To: INCITS Technical Committee T10
From: Fred Knight, Network Appliance
Email: knight@netapp.com
Date: 14 January, 2009
Subject: SBC-3 Thin Provisioning Commands

Figure B – Logical Block State Transitions

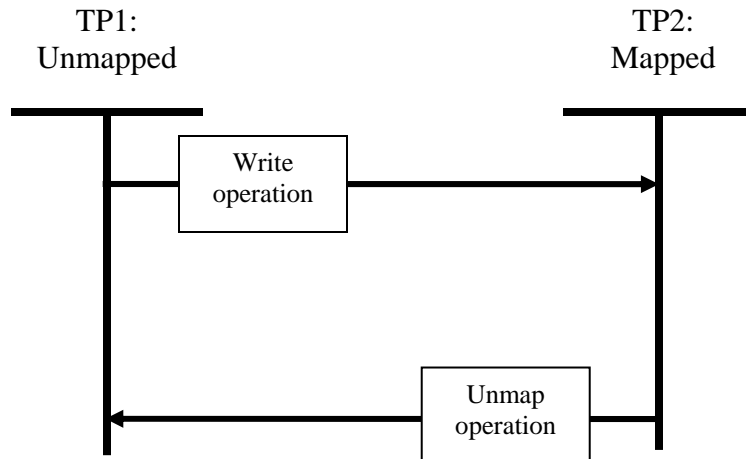
Transitions between the mapped and unmapped state are shown in figure B.

4.4.1.2 TP2: Mapped state

When in the mapped state, a relationship exists between the LBA and a physical block. User data and protection information read without error from a logical block in the mapped state shall be the user data and protection information that was most recently written to that LBA. If data has not been written to that LBA, user data and protection information read from the LBA shall be the user data and protection information that was established during initialization (see 4.7).

4.4.1.2.1 Transition TP2:Mapped state to TP1:Unmapped state

This transition occurs when an unmap operation completes without error (see 4.4.1.5.2). As a result of this transition, the user data retrieved by the next read operation may be indeterminate (see TPRZ bit in READ CAPACITY(16) parameter data (6.4.3)).

4.4.1.3 TP1: Unmapped state

4.4.1.3.1 Transition TP1:Unmapped state to TP2:Mapped state

This transition:

- a) shall occur when a write operation occurs. As part of processing a write operation, the device server may cause LBAs other than those specified by that write operation to transition from unmapped state to mapped state; or
- b) may occur at any other time for vendor specific reasons.
